**SAN ANTONIO WATER SYSTEM
CENTRAL WATER INTEGRATION PIPELINE
MALTSBERGER PUMP STATION IMPROVEMENTS
SAWS Job No. 18-8617
SAWS Solicitation No. CO-00190**

**ADDENDUM No. 3
August 30, 2018**

1
36" FLOW METER AND FLOW CONTROL VALVE ASSEMBLY
E-2312 SCALE: 3/8" = 1'-0"

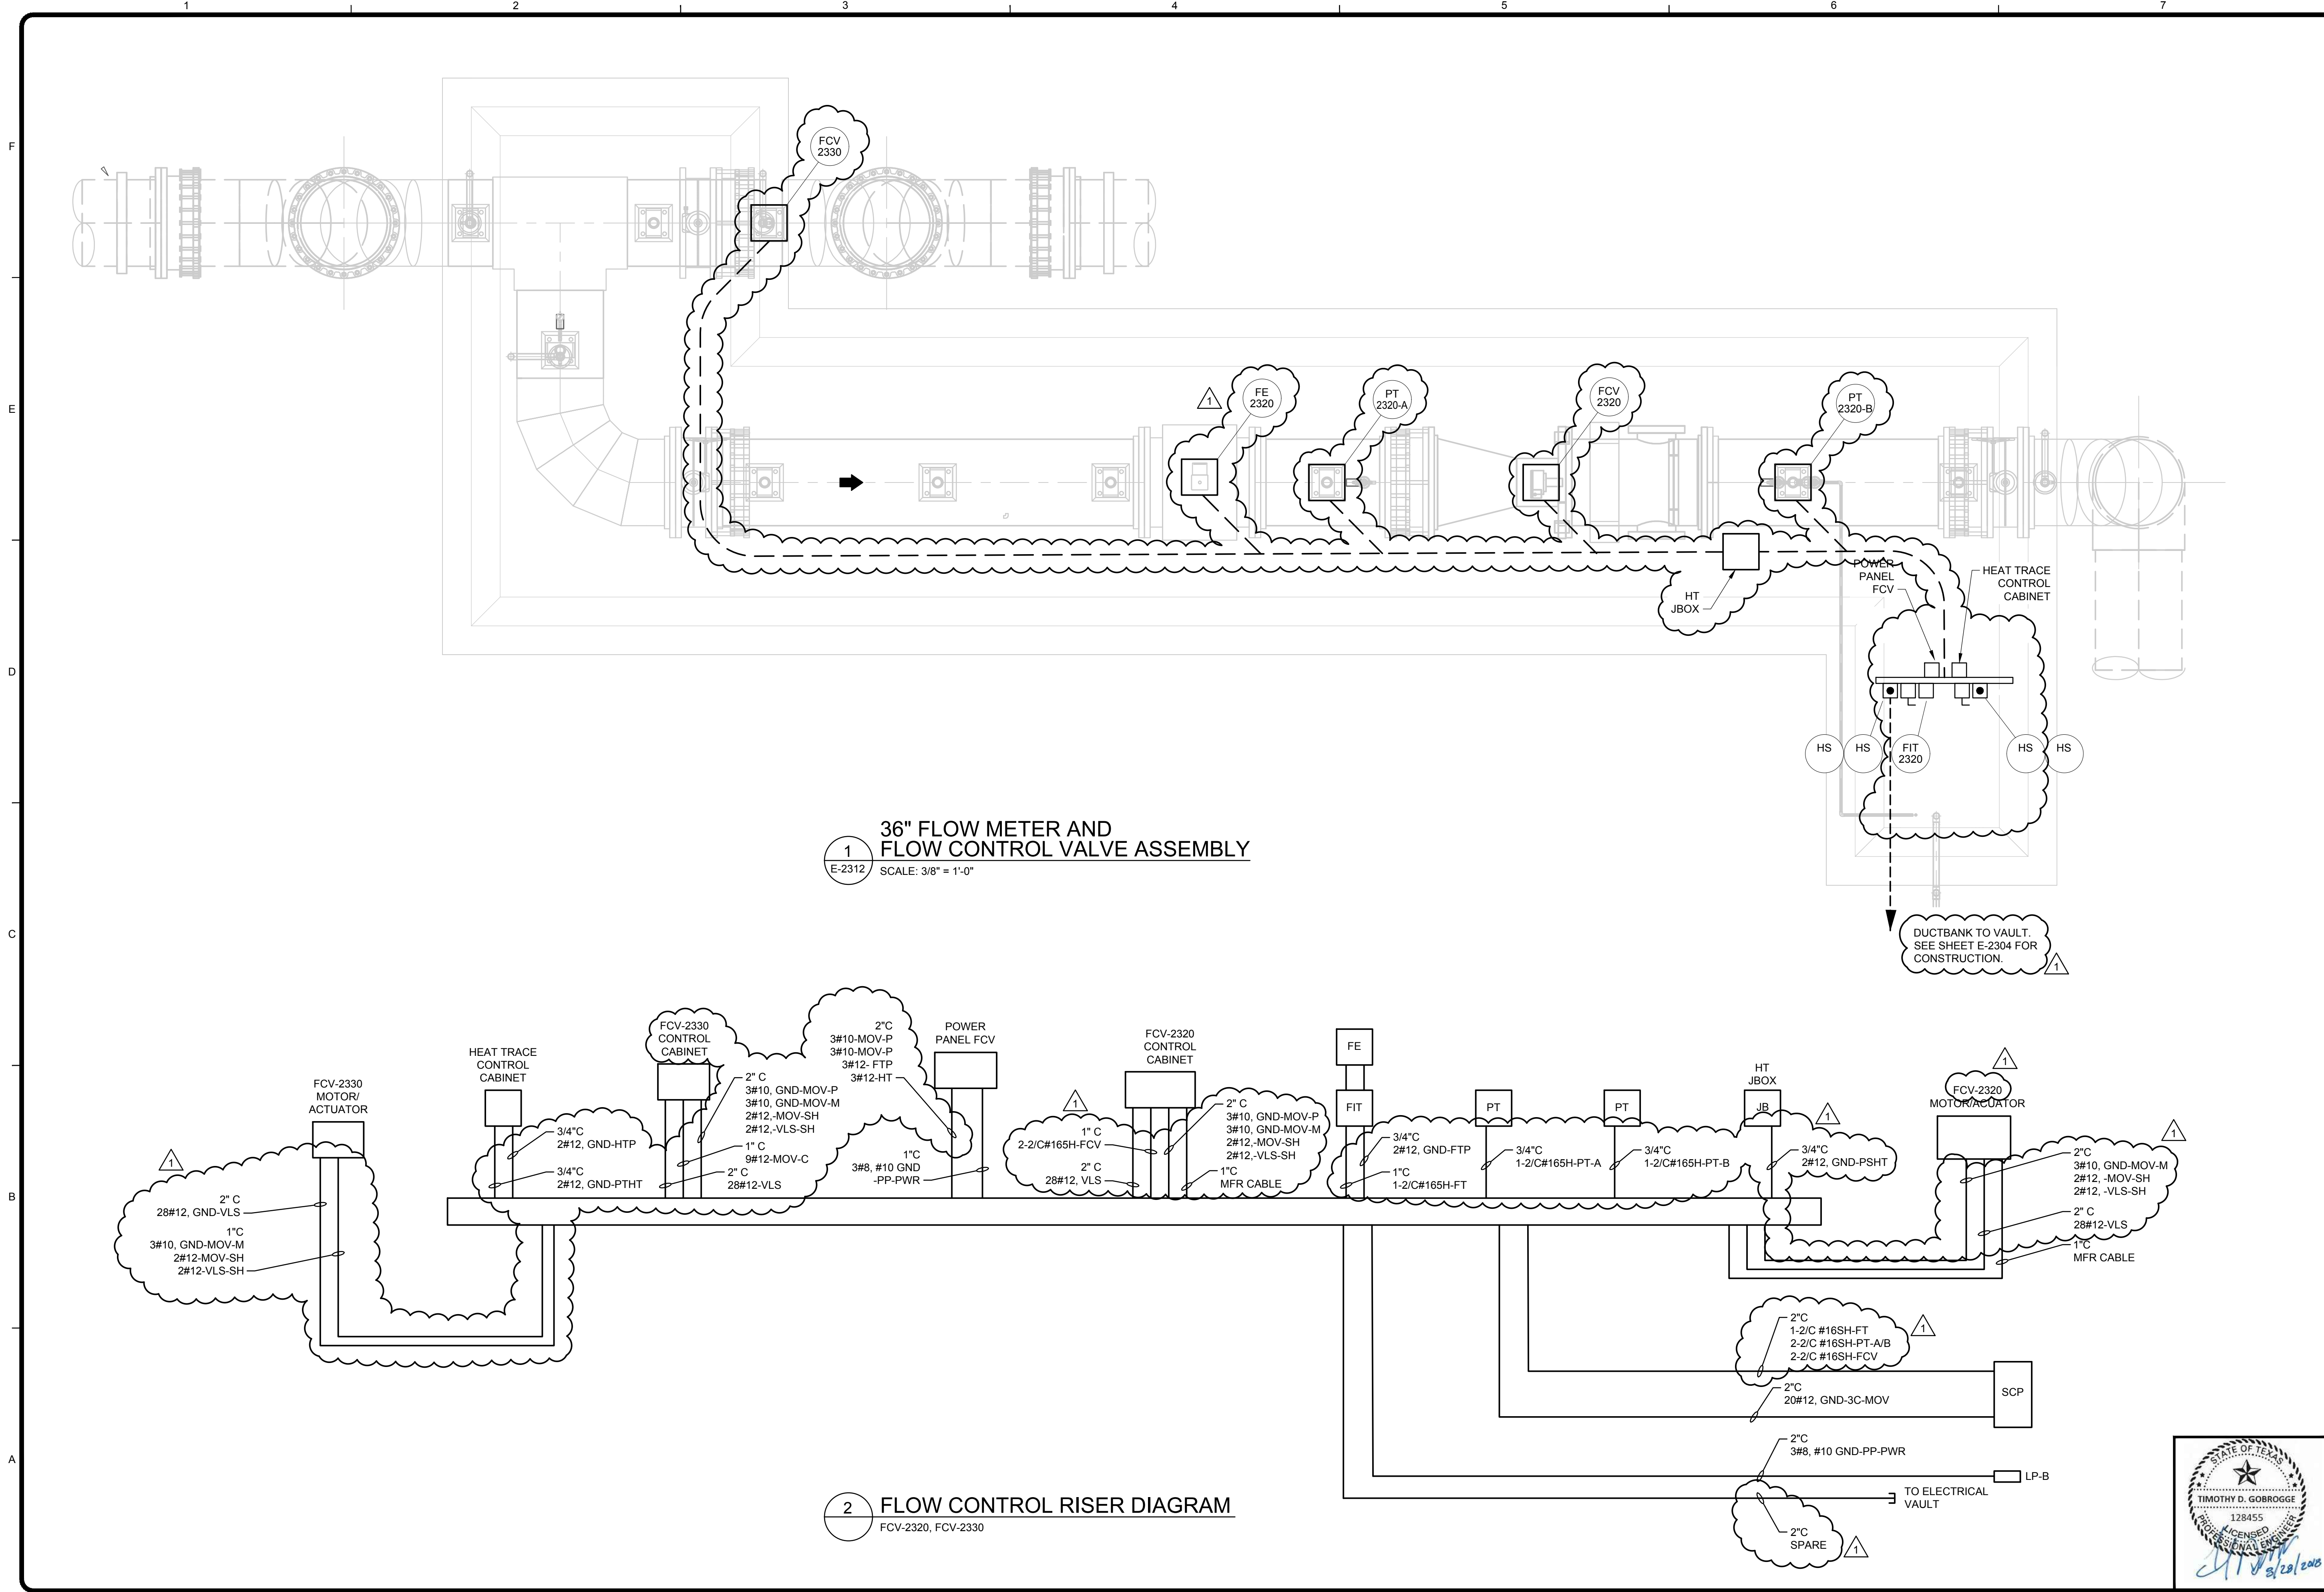
Question No.	Question	Answer
36	Sheet E-2324: Please revise and identify equipment shown on the "36" FLOW METER AND FLOW CONTROL VALVE ASSEMBLY" so it coincides with the "FLOW CONTROL RISER DIAGRAM".	Updated plan and riser diagram is provided. This is reflected in the changes to SHEET E-2324 per Addendum No. 3.
37	Sheet E-2324: Please revise and identify raceways, raceway sizes, and contents shown on the "FLOW CONTROL RISER DIAGRAM"	Updated plan and riser diagram is provided. This is reflected in the changes to SHEET E-2324 per Addendum No. 3.
38	Sheet E-2324: Two disconnects are shown on the "36" FLOW METER AND FLOW CONTROL VALVE ASSEMBLY" but not on the riser diagram. Please revise.	Updated plan and riser diagram is provided. This is reflected in the changes to SHEET E-2324 per Addendum No. 3.
39	Sheet E-2336: Please revise and identify raceways and conductors so they match relatable documents. For example, WT, BE, GND-M-SH do not appear on any schedules found in the bid documents.	Updated riser diagram is provided. GND is an abbreviation listed on SHEET E-2301 for GROUND. The remainder are listed either on one-lines or wiring diagrams. This is reflected in the changes to SHEET E-2326 per Addendum No. 3.

1 FLOW CONTROL VALVE
E-2341 SCALE: 3/8" = 1'-0"

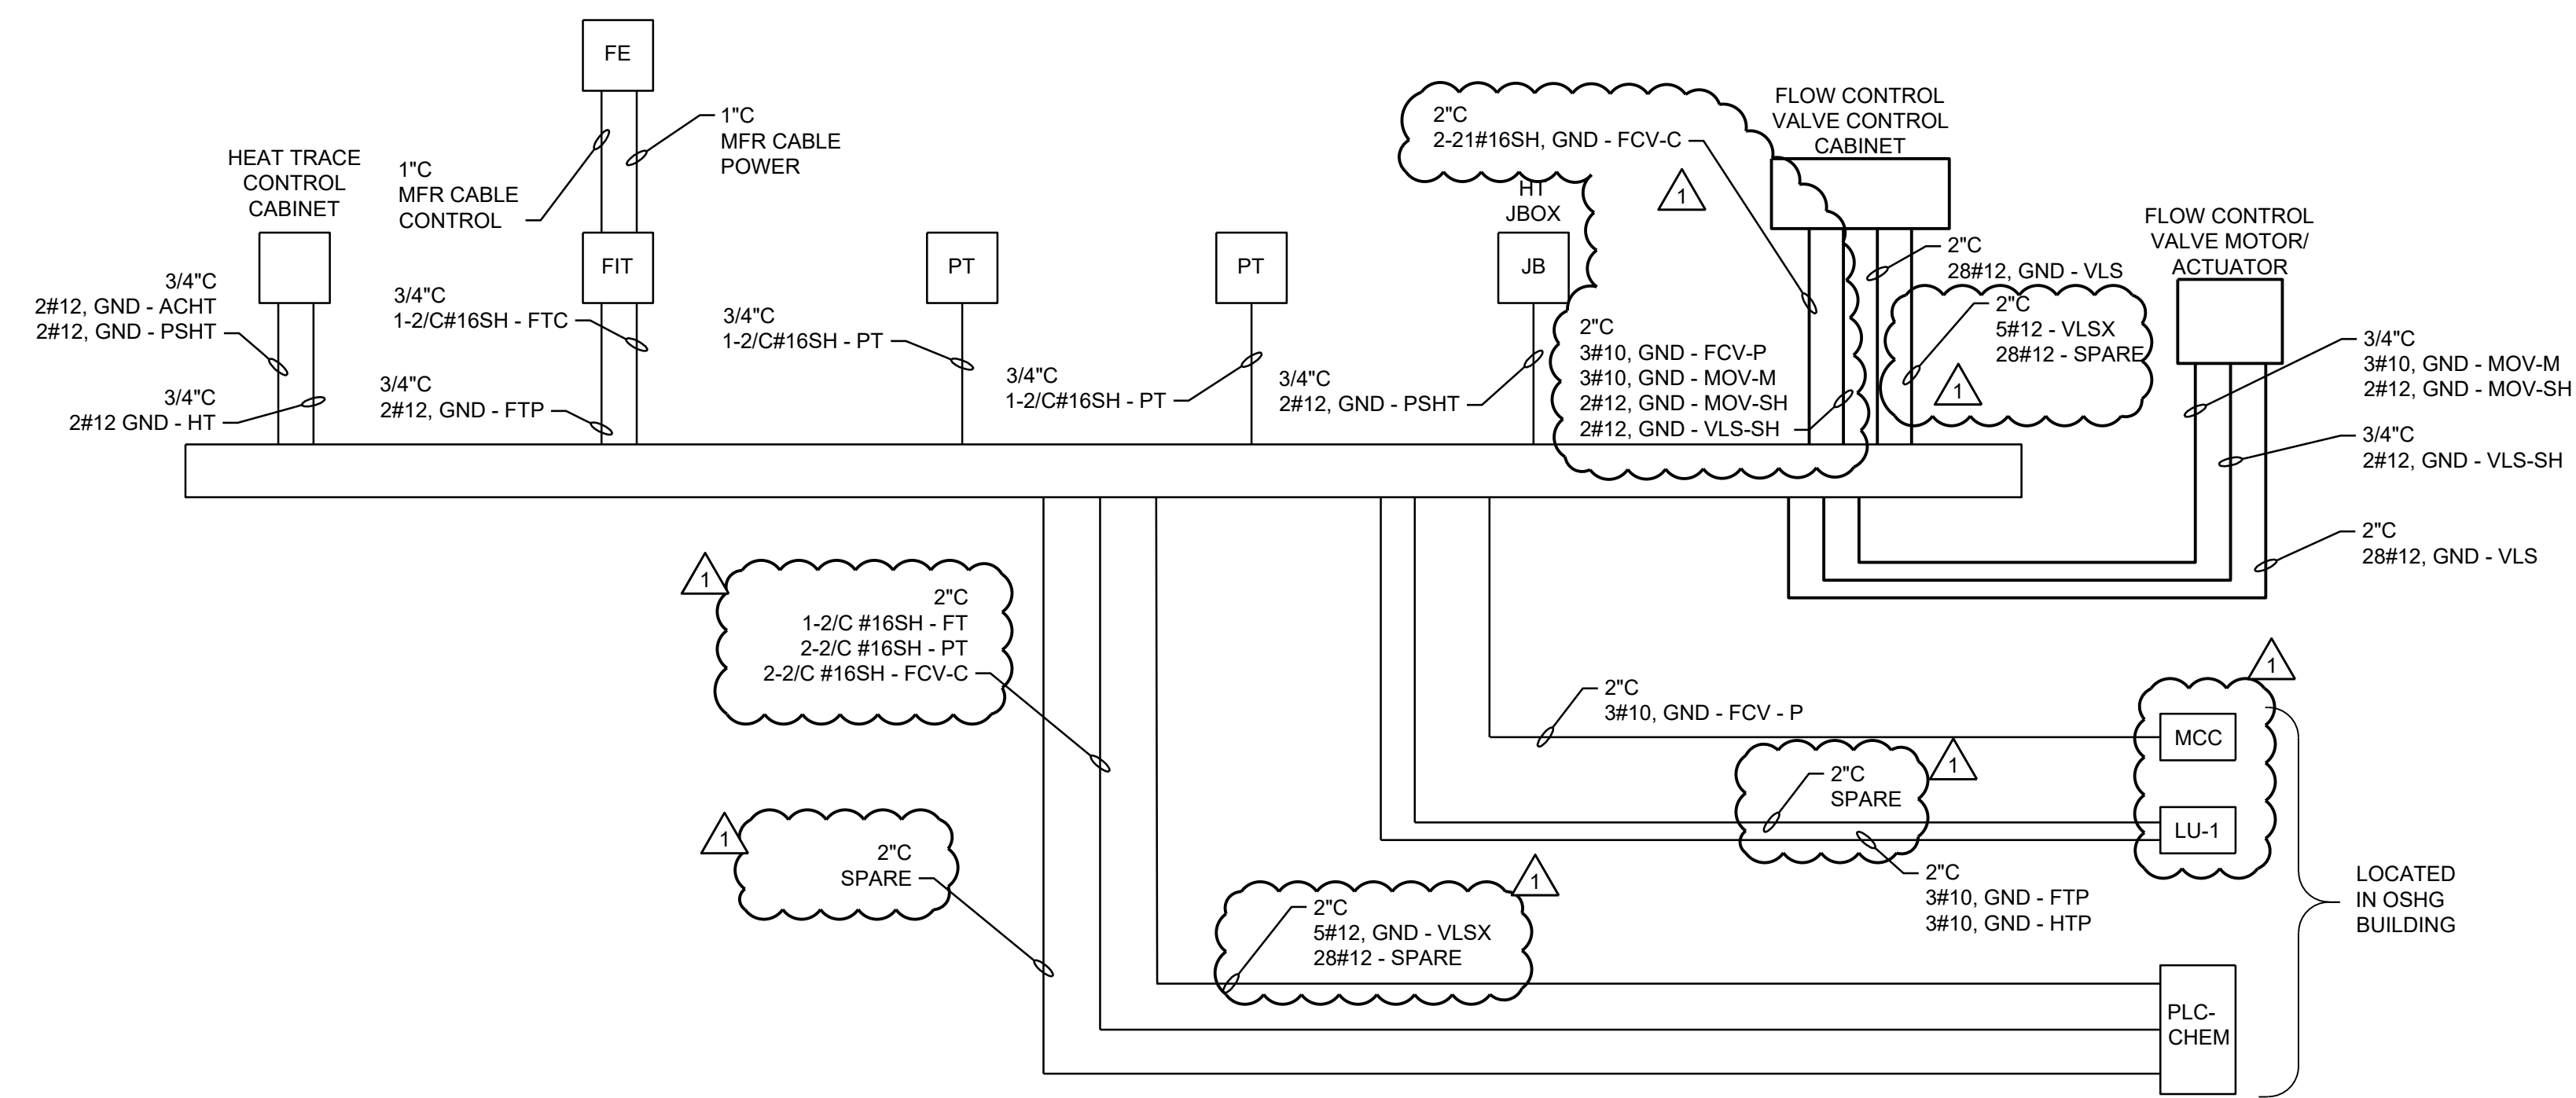
40	Sheet E-2337: Please revise and identify raceways and conductors.	Updated riser diagram is provided. This is reflected in the changes to SHEET E-2327 per Addendum No. 3.
41	Sheet E-2343: "FLOW CONTROL VALVE" illustrates a disconnect between the FIT and FCV control cabinet, there is no disconnect shown on the "FLOW CONTROL RISER DIAGRAM". Please revise and provide size and rating of this disconnect.	Updated plan and riser diagram is provided. This is reflected in the changes to SHEET E-2343 per Addendum No. 3.
42	Sheet E-2343: "FLOW CONTROL RISER DIAGRAM", between the MCR and PLC-CHEM is an item with no label. Please identify.	Updated riser diagram is provided. This is reflected in the changes to SHEET E-2343 per Addendum No. 3.
43	Sheet E-2351: Please provide a location for the CPS service pole and feeder from service to the electrical panelboard.	This information will be provided in a future Addendum.

LATTICE TYPE ANTENNA MAST DETAIL

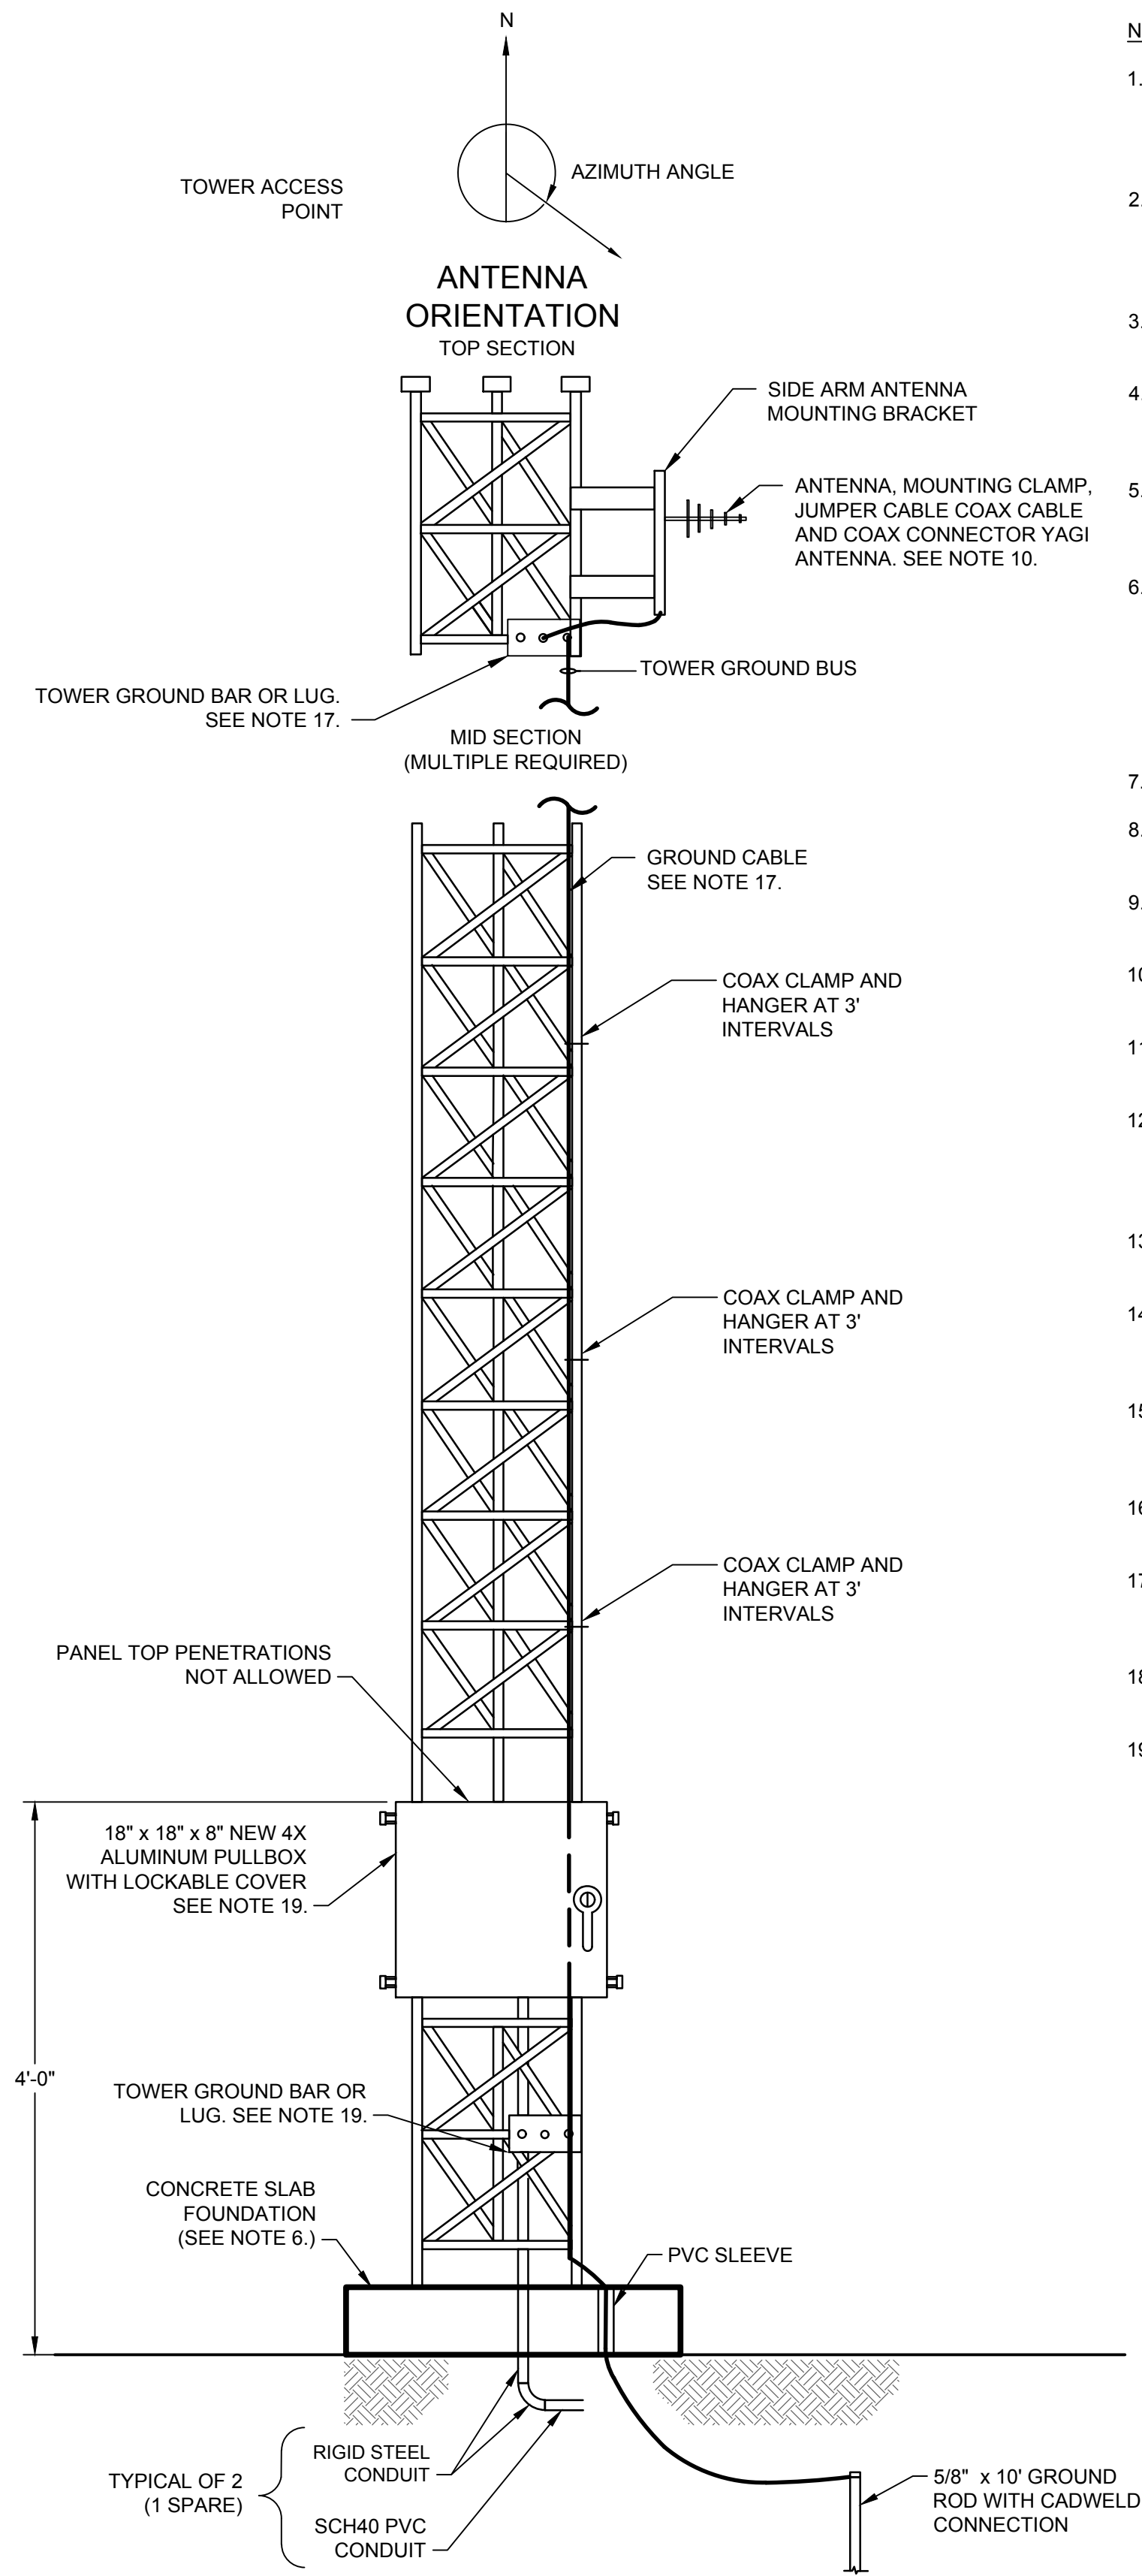
24	Sheet E-2303: See Note 9, please provide existing tower type (mono-pole, ladder, etc.) and height.	Details for the existing tower have been added to the plans. This is reflected in the changes to SHEET E-2393 per Addendum No. 3.
25	Sheet E-2304: Tower notes, please provide detail for raceway routing, size, and confirm that new coaxial cable is needed. Sheet I-2311 shows coaxial cable is existing, but the new location will require new cable. Please clarify.	New coaxial cable will be required. This is reflected in the changes to SHEETS E-2393 and I-2311 per Addendum No. 3.
26	Sheet E-2304: Tower notes, please provide detail for raceway routing, size, and confirm that new coaxial cable is needed. Sheet I-2311 shows coaxial cable is existing, but the new location will require new cable. Please clarify.	New coaxial cable will be required. This is reflected in the changes to SHEETS E-2393 and I-2311 per Addendum No. 3.

1. CONTRACTOR SHALL RELOCATE EXISTING TOWER AS SHOWN ON SHEET E-2304. CONTRACTOR SHALL FURNISH AND INSTALL NEW ANCHOR BASE TO MATCH EXISTING TO ATTACH TOWER TO NEW CONCRETE PAD.
